**Submission on Draft Environmental Impact Report (DEIR)
MassDOT I-90 Allston Interchange Improvements Project:**

Comment #4 : Draft EIR for I-90 (EEA # 15278) : CONCLUSIONS on Highways, Transit and Traffic

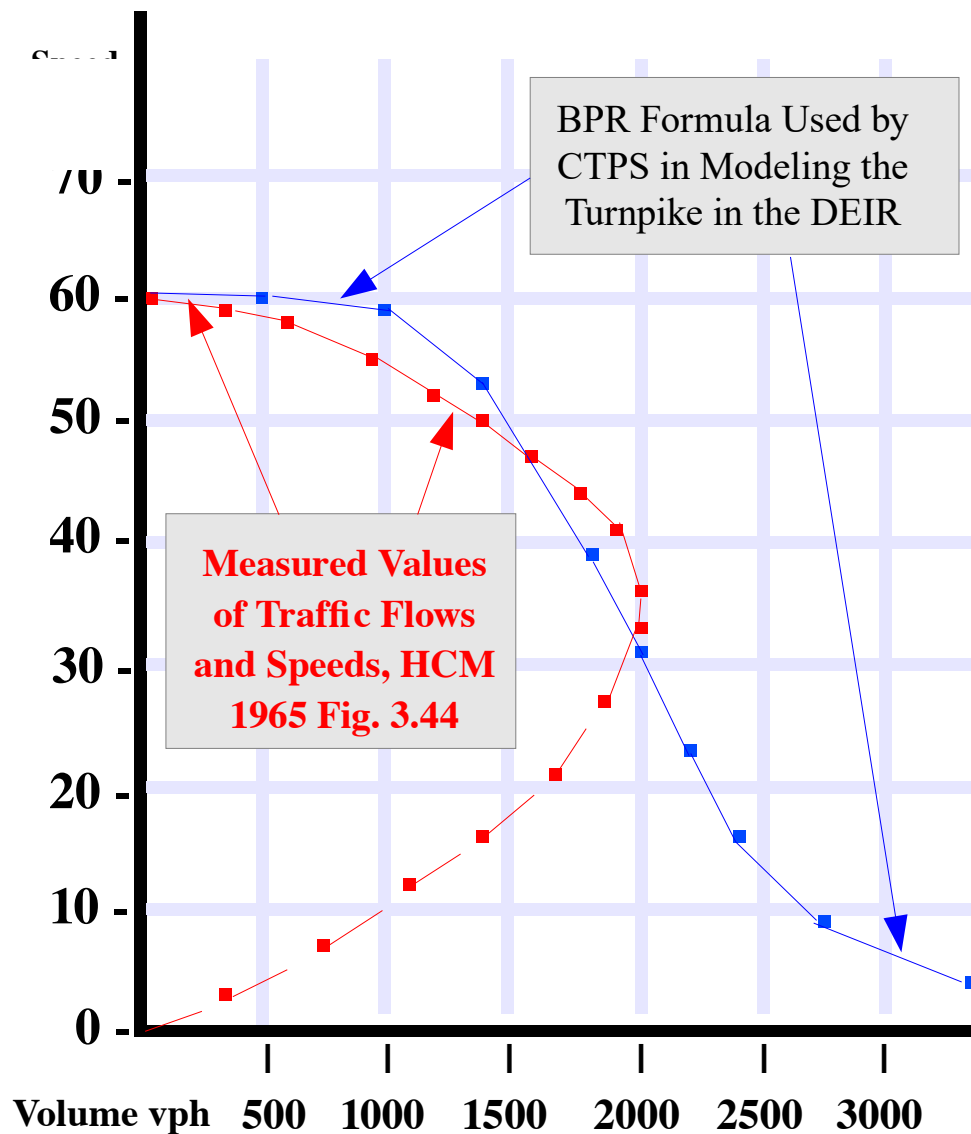
For the Final EIR, CTPS should investigate the history and accuracy of the BPR formula in terms of its allowance of volumes to exceed capacity, and for volumes to increase as speeds drop below 30 mph. They should candidly conclude whether after fifty years the BPR formula should be abandoned, and instead a true trapezoidal speeds/volume formula adopted.

The first place for CTPS to apply the modeling result is to compare the model results with the traffic measurements on the Turnpike as recorded as count station AET12, with appropriate sampling of the Turnpike measurements to reflect the notable volatility in speeds and volumes during peak hours.

The next step would be to design a speed/volume formula which is indeed roughly parabolic in shape, and include it in the computer model instead of the disgraced BPR formula. The result should be expressed in a way to flag all links and

The **RED** represents measured values for speed and flow, with a parabolic shape to the curve. The BPR Formula shown in **BLUE** is a theoretical construct that shows no evidence of low-speed correlation to the empirical traffic data and no evidence of either validation or calibration.
